SERVICE LETTER NO. 77-3
"FAA (DER) APPROVED"
PAGE 1 OF 3 PAGES

18 November 1977

CANOPY LOCK RELEASE LEVER PLACARD

AA5 -0001 thru AA5 -0834 AA5A-0001 thru AA5A-0455 AA5B-0001 thru AA5B-0593

FIGURE |

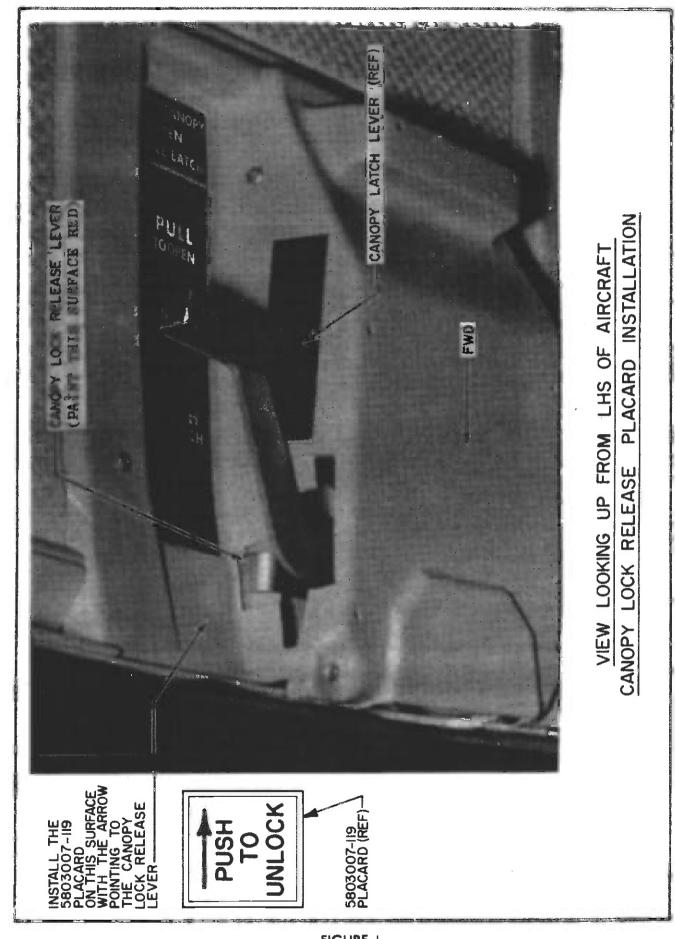
The canopy lock release lever is located just above the internal canopy latch handle (See Figure No. 1). Actuation of this lever enables a person to temporarily override the canopy lock and open the canopy.

To be certain pilots and passengers are able to identify and operate this feature, Grumman American has incorporated a "PUSH TO UNLOCK" placard. Part No. 5803007-119.

## INSTALLATION INSTRUCTION: (SEE FIGURE 1)

This additional placard is to be installed forward of the internal canopy latch placard (REF: Part No. 5803007-23) which is located on the canopy headliner center royalite cover and to the left of the canopy latch assembly. Thoroughly clean the royalite in this area with isopropyl alcohol. When the area is completely dry, remove the protective backing from the placard and firmly press it in place. Paint the external surface of the Canopy Lock Release Lever bright red. Make a log book entry into the Aircraft Log that Service Letter No. 77-3 has been complied with.
